Product Change Notice (PCN)

PCN Number: PCN-0451156R-01

Product(s) Affected: PJ-039A, PJ-039B, PJ-039AH, PJ-039BH

Current version	New version
Outlook		
Front	<p>without chamfer</p> 	<p>with chamfer</p>

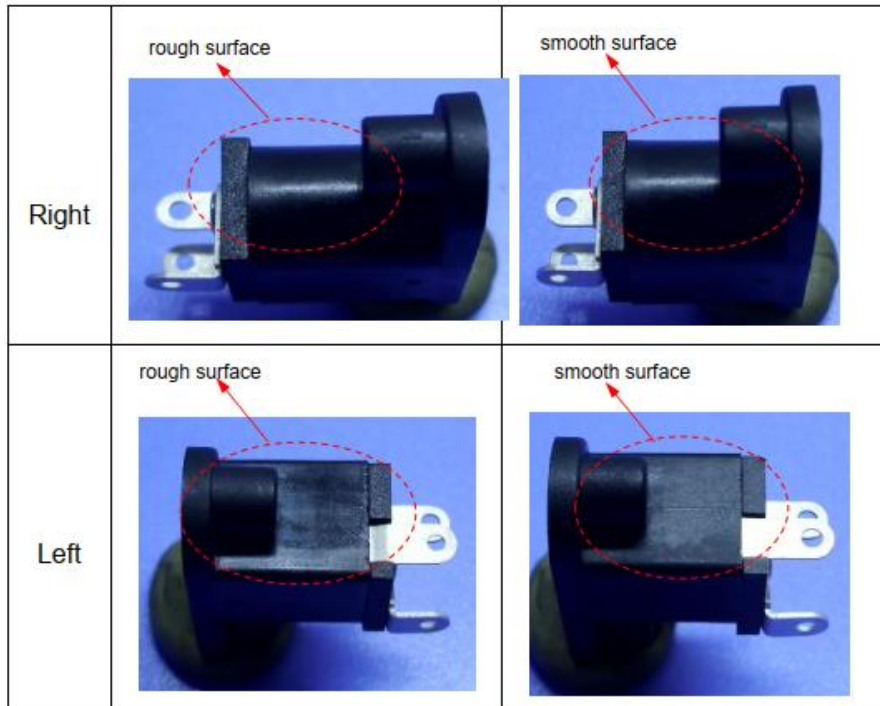
Description of Change: Thickness of pin 2 changed from 0.2mm to 0.25mm. Aesthetic changes as shown in below comparisons:

Back	<p>cave marking location</p>  <p>smaller</p> <p>cave marking location</p>	<p>cave marking location</p>  <p>thicker</p> <p>cave marking location</p>
Top	<p>with injection mark</p>  <p>thickness of pin#2 is 0.2mm</p>	<p>without injection mark</p>  <p>thickness of pin#2 is 0.25mm</p>
Bottom	<p>without injection mark</p> 	<p>with injection mark</p>
